BENSTEAD PLUGS
5-28-13

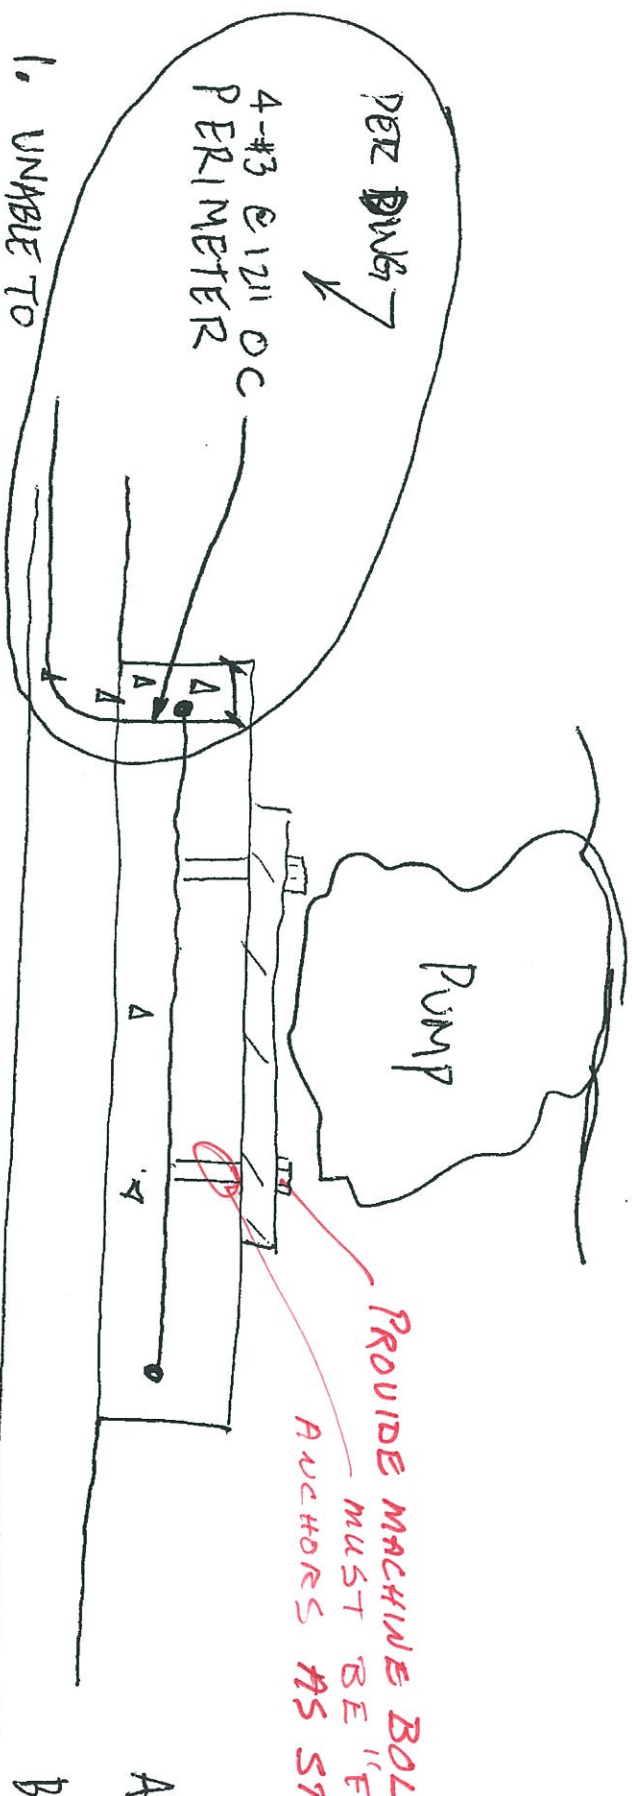
1. UNABLE TO
DO BECAUSE
OF ONLY 6" FLOOR
& then Room (Sump) Below

2. CAN IT BE ACCEPTABLE TO
Place Rebar 4-#3 @ 12" OC
but in fashion shown below:

PROVIDE MACHINE BOLT.
MUST BE "FEMALE"
ANCHORS AS SPECIFIED

NO

MIN. 3" EMBEDMENT w/ HILT
44-150.
